## **Addendum No. 1**

To: **All Contractors**  
Date: May 10, 2022  
Re: **Lincoln County Ambulance District**  
Base Station 2  
28 Walter Court  
Moscow Mills, Missouri 63362

New Base Station #2 Facility for:  
**Lincoln County  
Ambulance District**  
28 Walter Court  
Moscow Mills, Missouri 63362

SHEET  
**M2.1**  
MECHANICAL PLAN

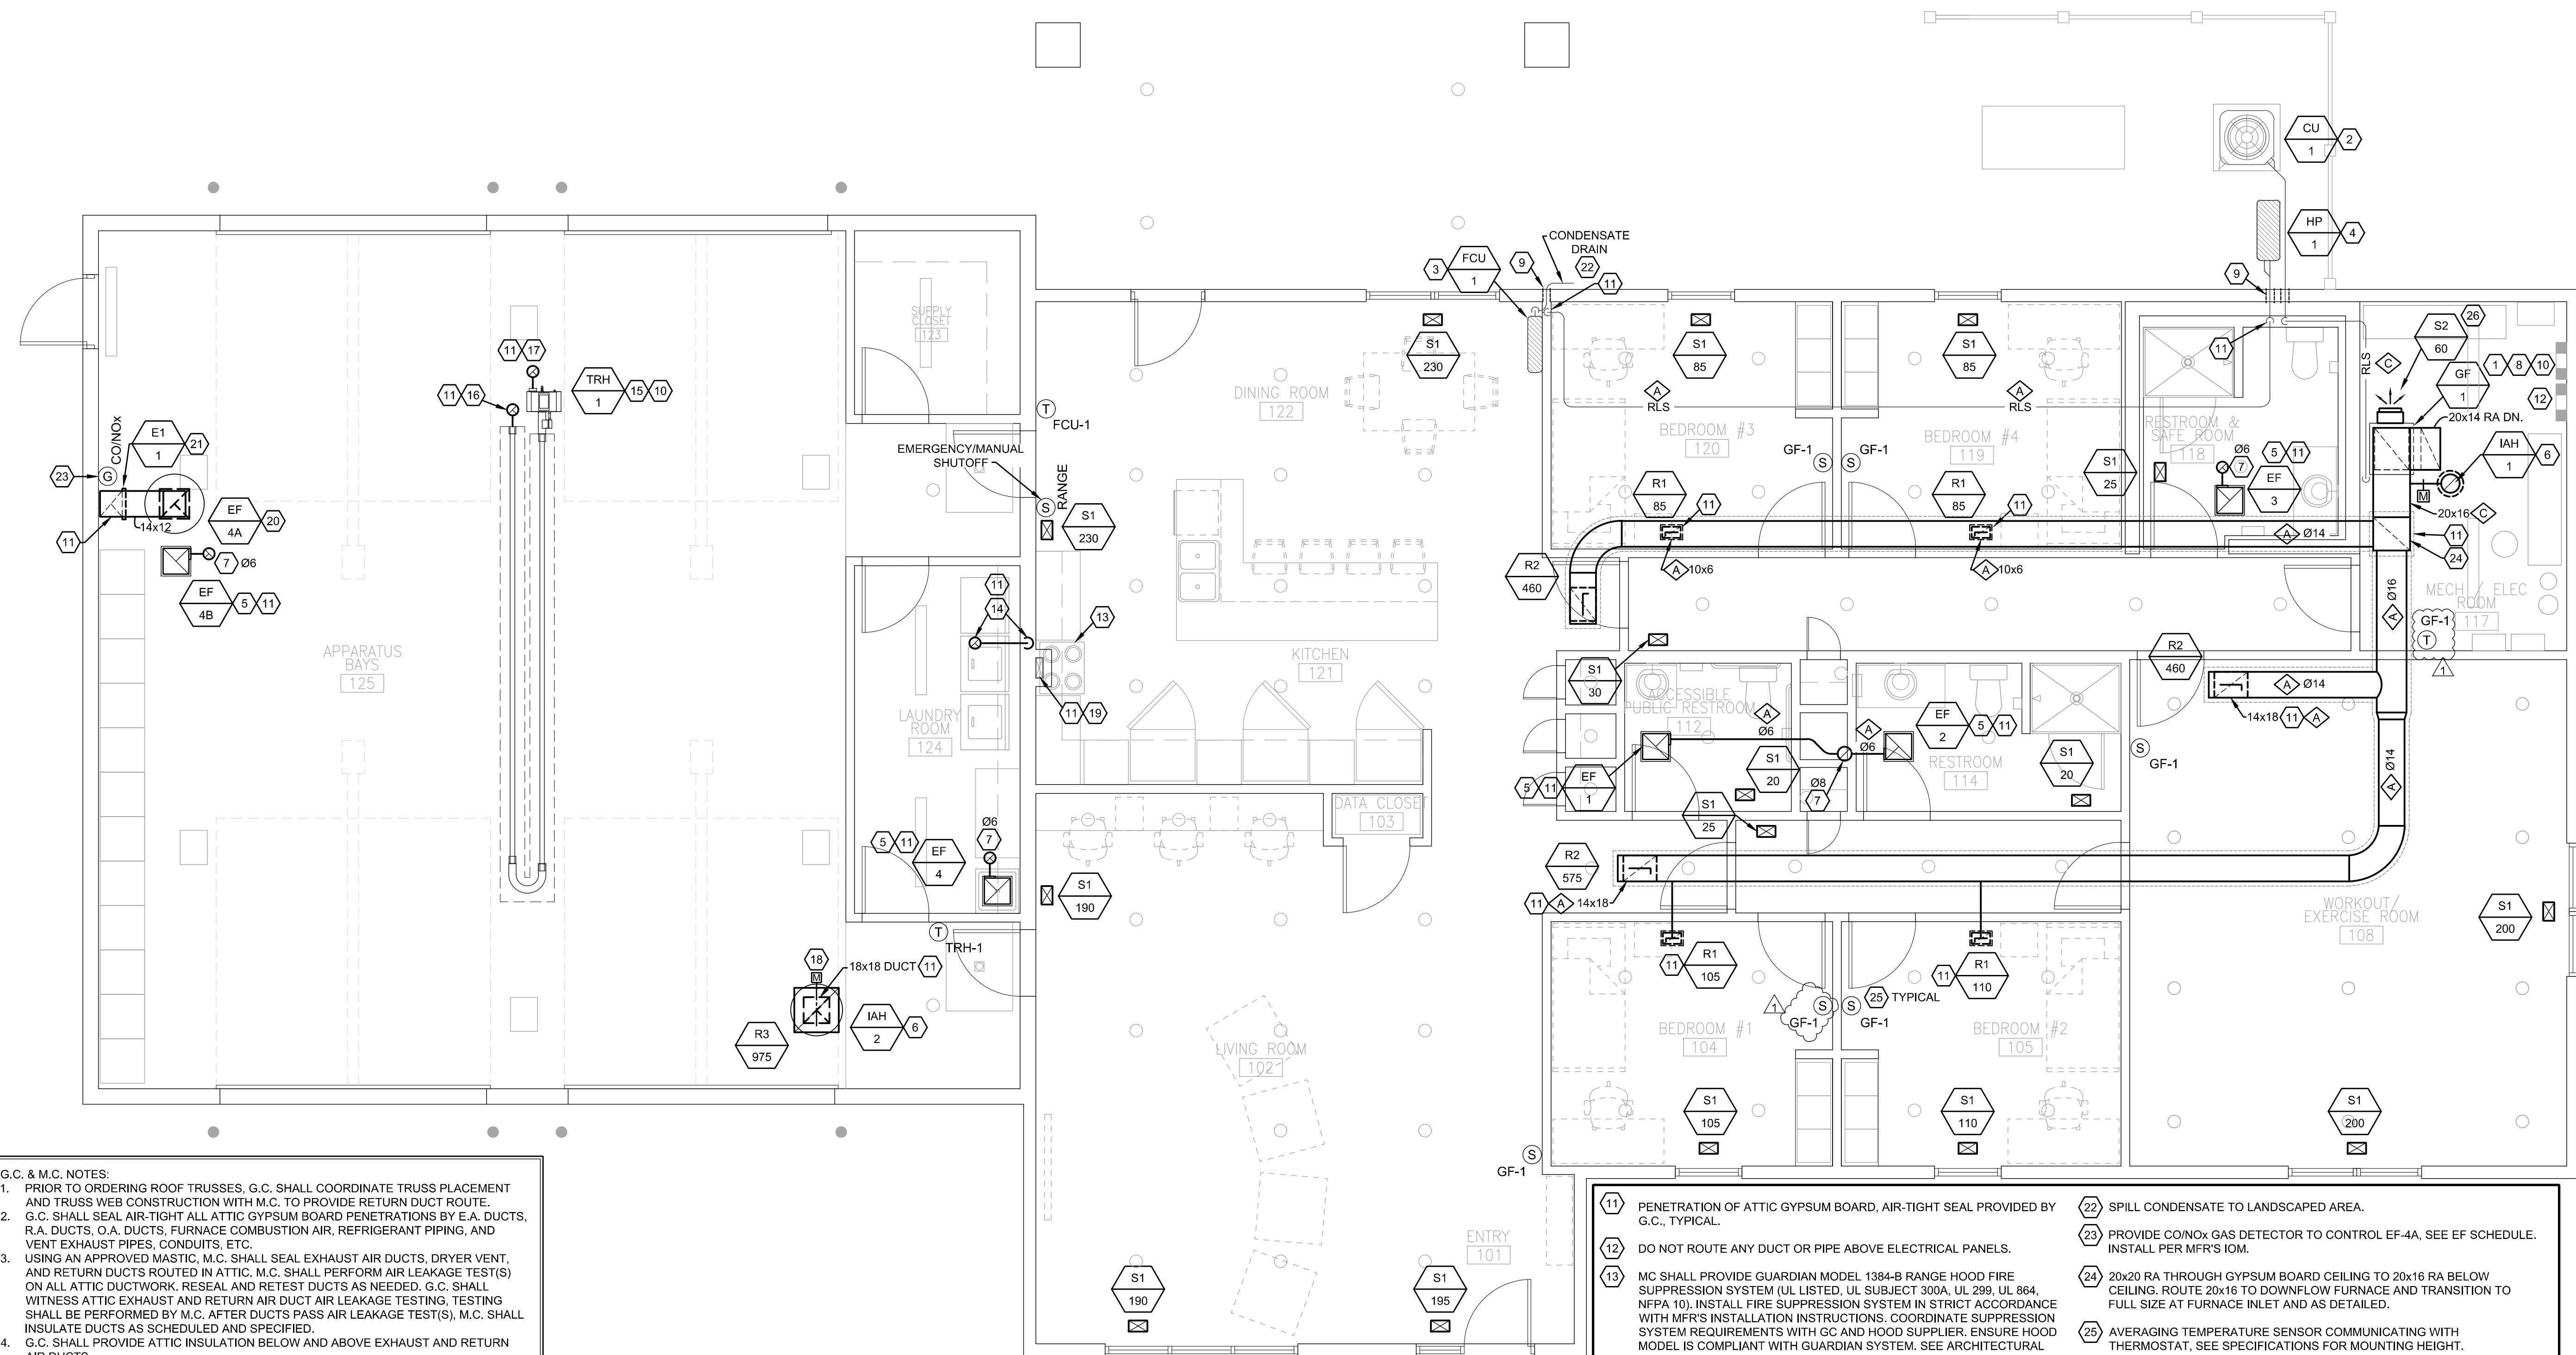
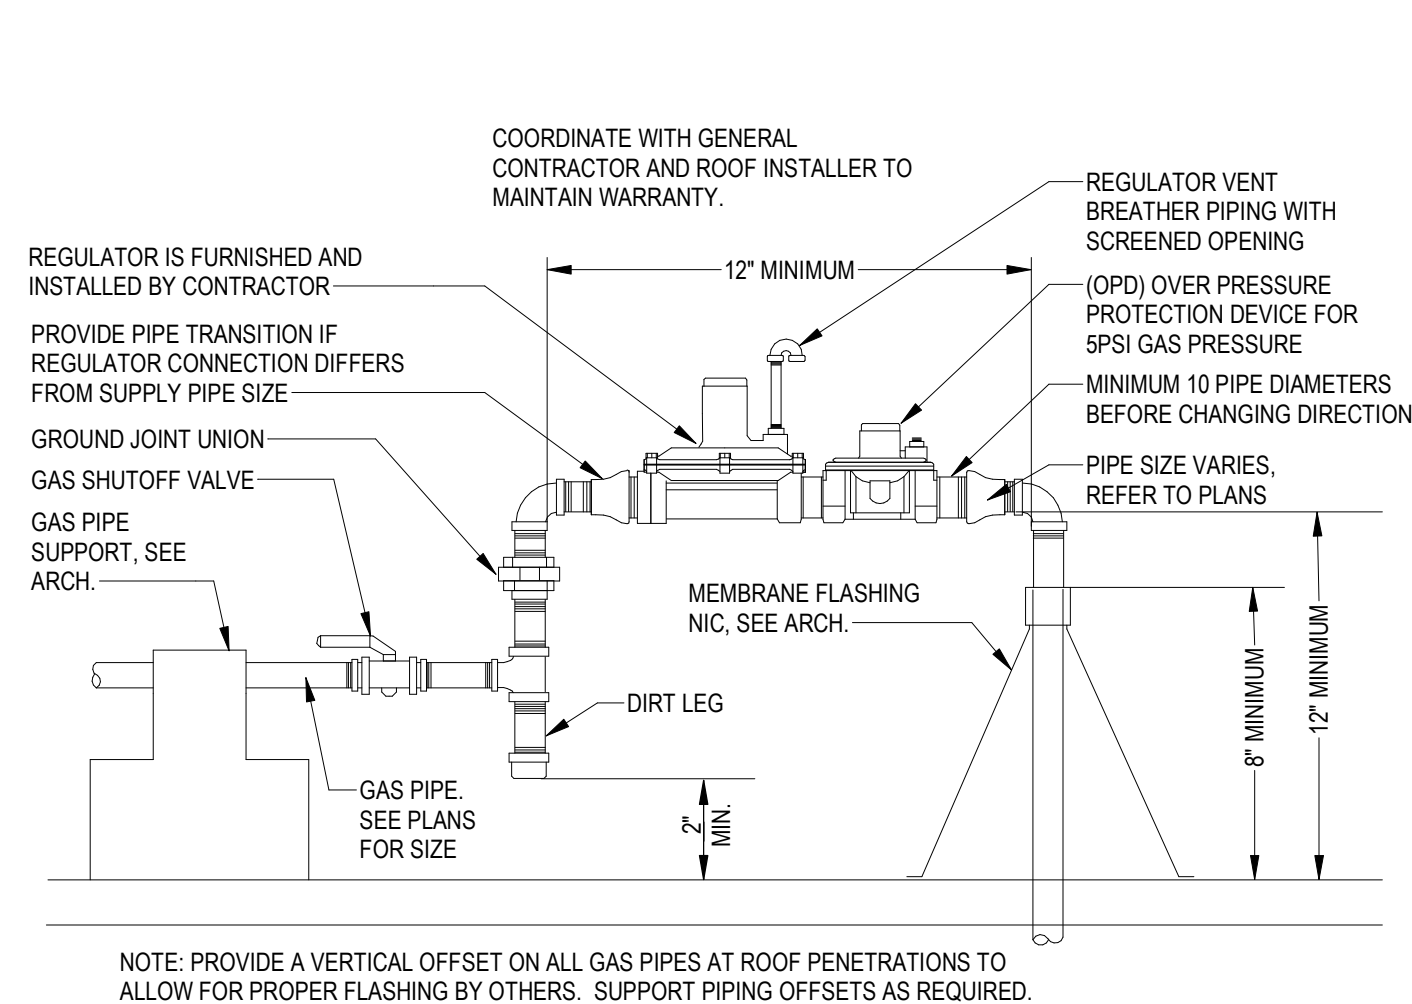
8. Sheet M1.0, Mechanical Schedules – Revised drawing issued.
  - a. Updated the DLSS HP-Fan coil unit schedule.
  - b. Revised the Air Hood Schedule.
9. Sheet M2.1, Mechanical Plan – Revised drawing issued.

- a. Added sensor to Room 104
  - b. Added thermostat to Room 117
10. Sheet P101, Water and Gas Plan – Revised drawing issued.
  - a. Revised domestic water lines to below grade.

SHEET  
**P101**  
WATER AND GAS PLAN

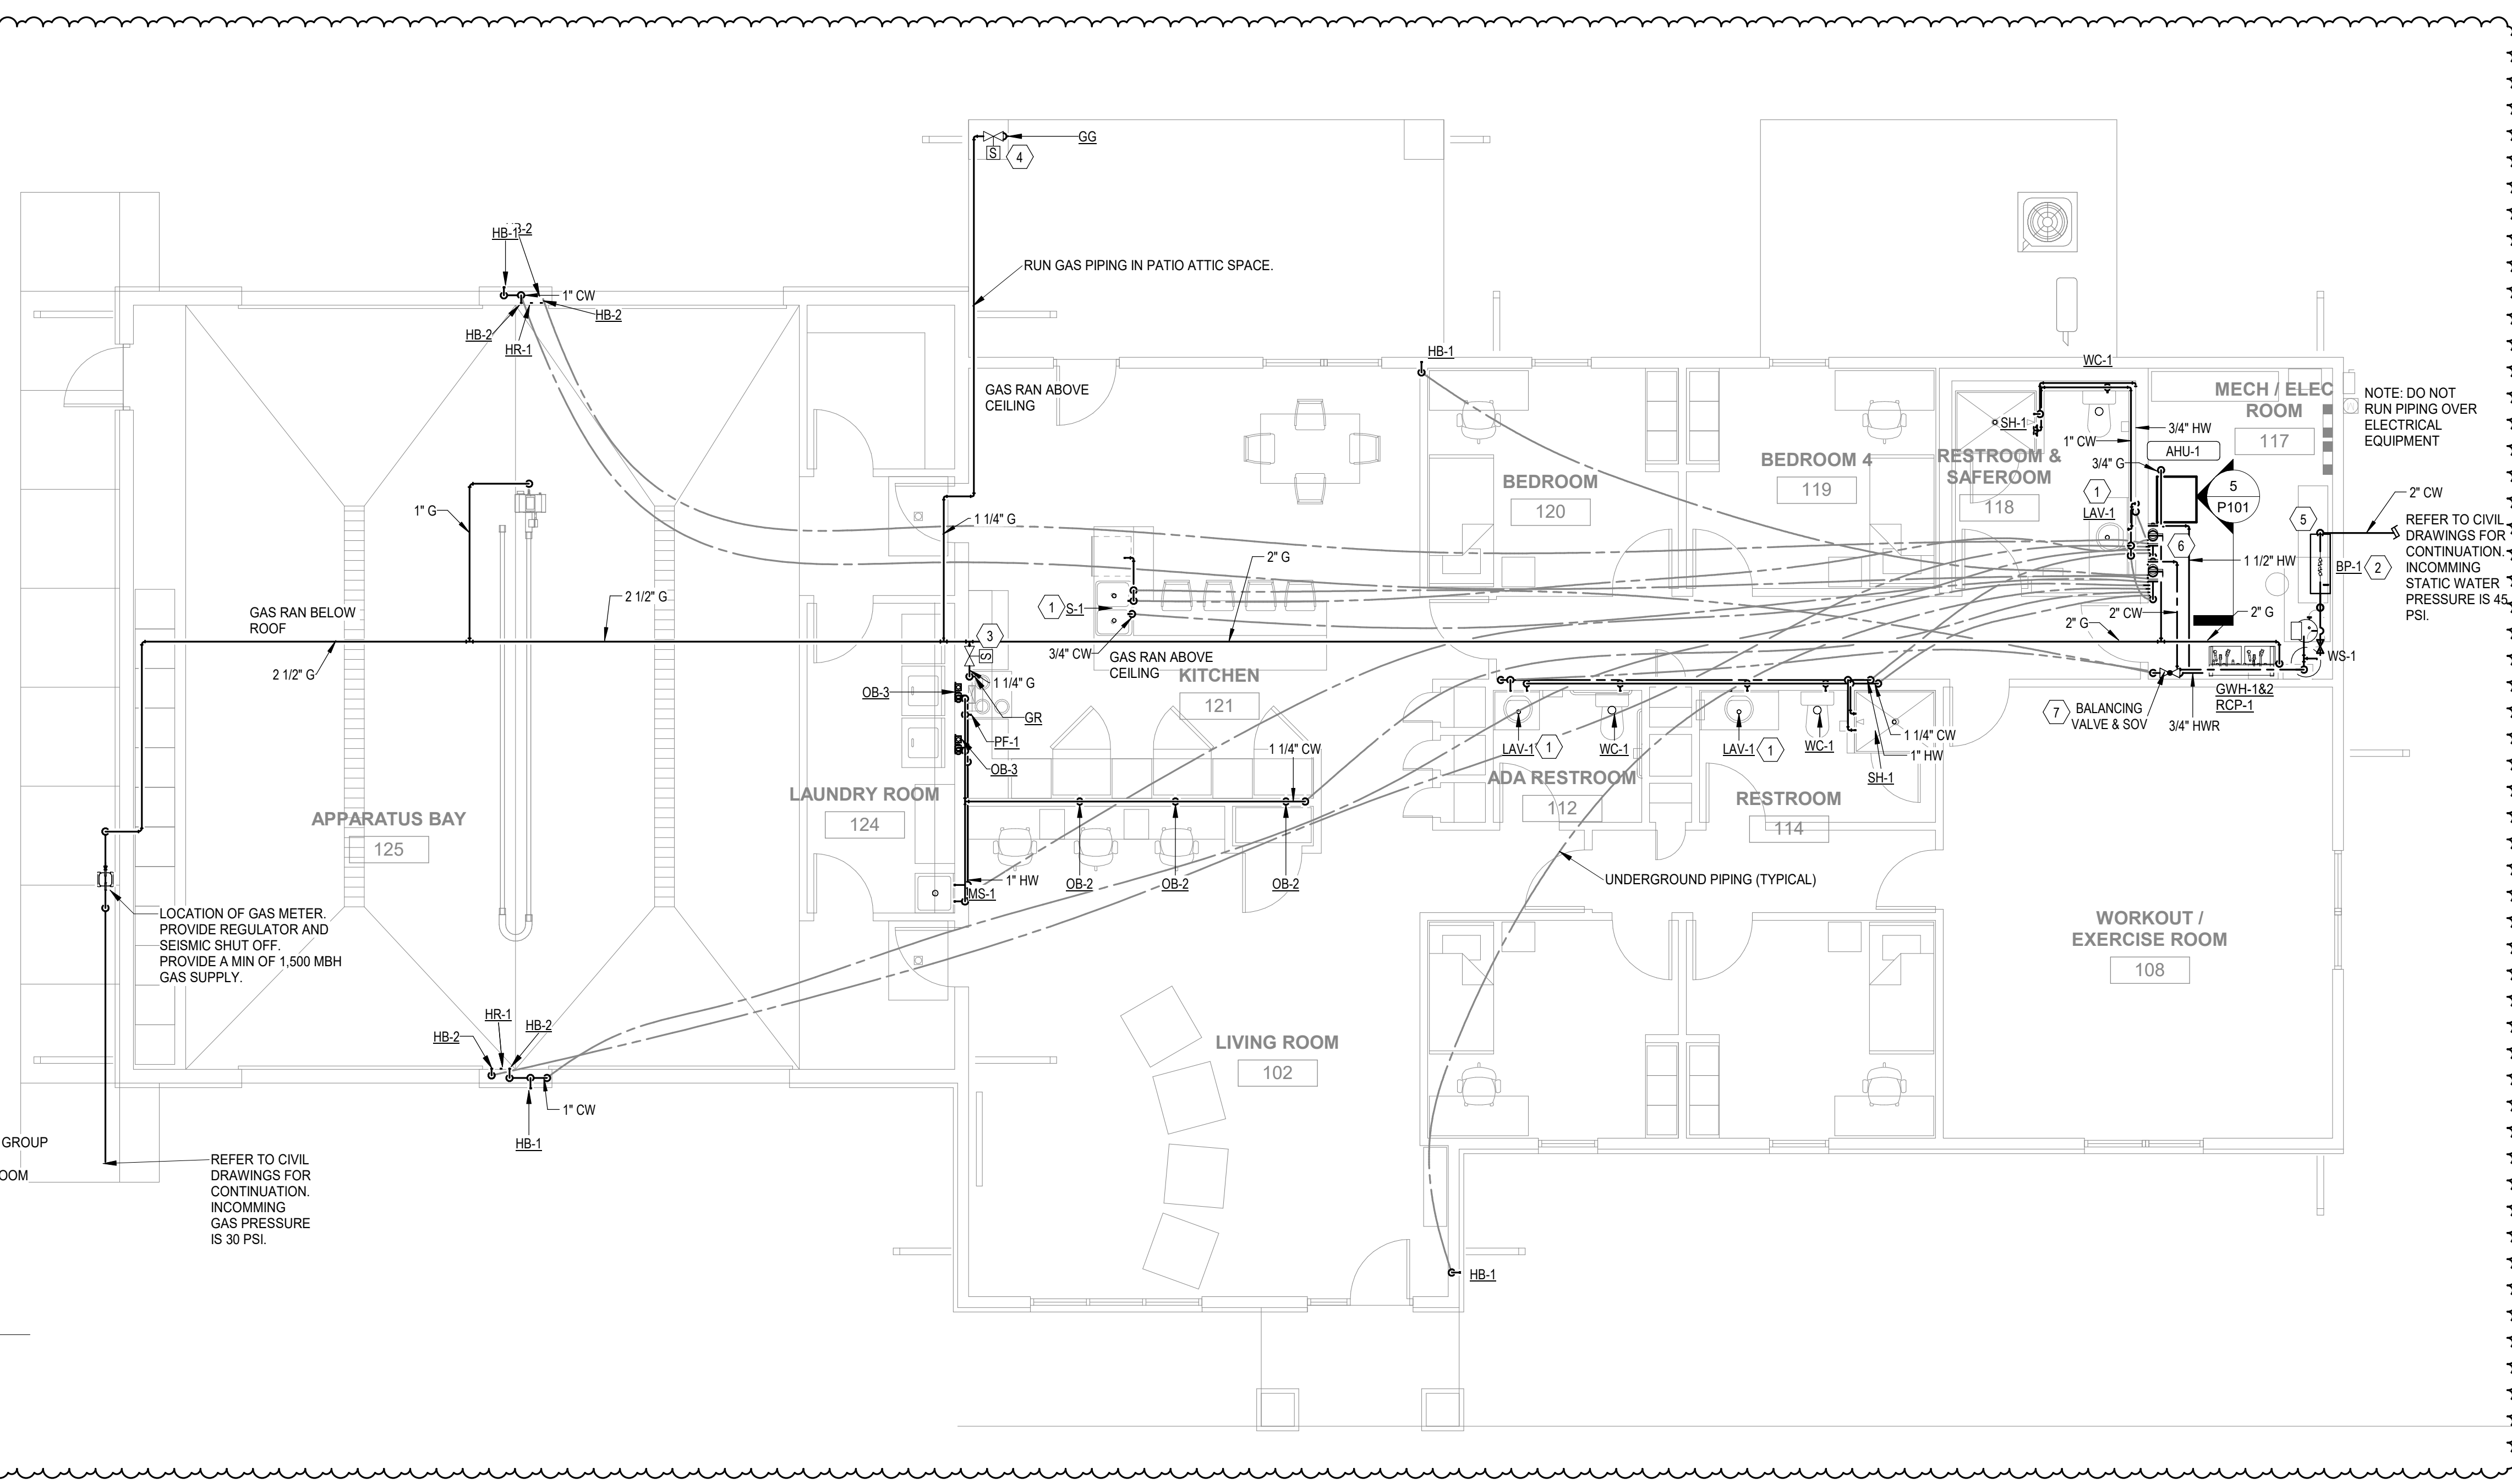
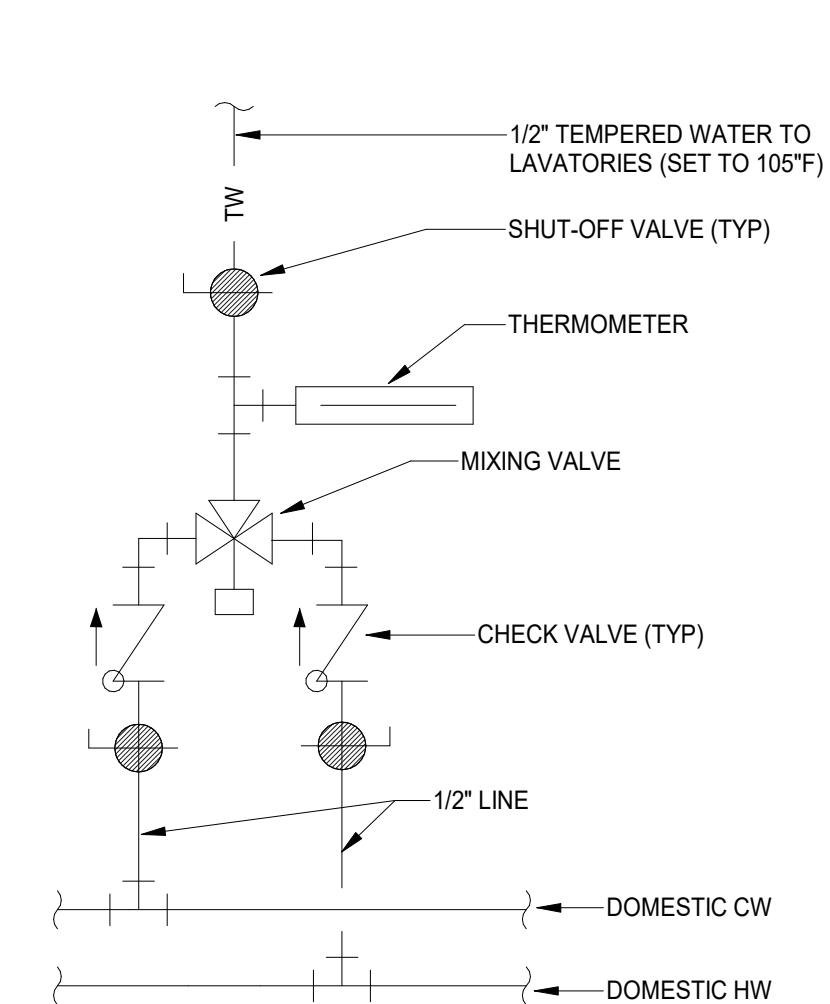
- b. Added Domestic Water Manifold Detail.
11. Sheet P300, Plumbing Isometrics – Revised drawing issued.
  - a. Domestic Water Isometric Plan - Revised domestic water lines to below grade.
